**Washington State**  
**ENERGY FACILITY SITE EVALUATION COUNCIL**

BP Cherry Point Cogeneration Project

Prevention of Significant Deterioration/Notice of Construction  
Permit No. EFSEC/2002-01

**RESPONSIVENESS SUMMARY**

Figure 1

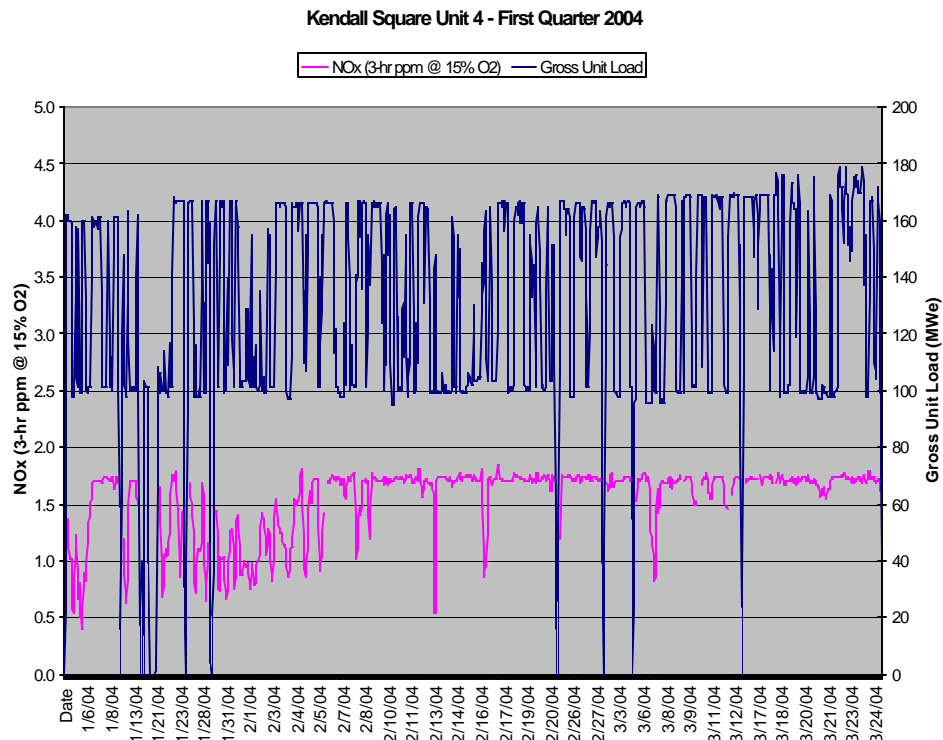
Comment 1: The Environmental Protection Agency's (EPA) Jeff KenKnight commented that the NO<sub>x</sub> BACT emission limit in condition 6.1.1 of the draft permit should be reduced from 2.5 to 2.0 ppm<sub>dv</sub>, three hour average, corrected to 15% O<sub>2</sub> in order to better reflect (1) information presented in the permit application for the Project submitted by BP, (2) recent BACT determinations for similar facilities in Washington, and (3) economic and technical feasibility considerations.

Response 1: Since submitting this comment, EPA has discovered new information that distinguishes BP's Cogeneration Project from combined cycle and combined cycle cogeneration facilities operating with a NO<sub>x</sub> emission limit of 2.0 ppm<sub>dv</sub> corrected to 15% O<sub>2</sub> (2 ppm NO<sub>x</sub>). EPA is no longer confident that a properly designed and functioning selective catalytic reduction (SCR) NO<sub>x</sub> control system at BP Cogeneration Project will be able to consistently achieve emissions reductions to below 2 ppm NO<sub>x</sub>. Thus, EPA and EFSEC are retaining the proposed 2.5 ppm NO<sub>x</sub> BACT emission limit.

Figure 1 presents KS4 first quarter 2004 CAMD data graphically. In preparing the data for presentation here, EPA chose to delete NO<sub>x</sub> concentrations above 5 ppm given that such concentrations are the result of startup or shutdown conditions during which the 2 ppm or 2.5 ppm NO<sub>x</sub> emission limitation is relieved. Such data would not be useful to this decisionmaking process (2.5 ppm vs 2.0 ppm NO<sub>x</sub> BACT) and would only clutter the graph.
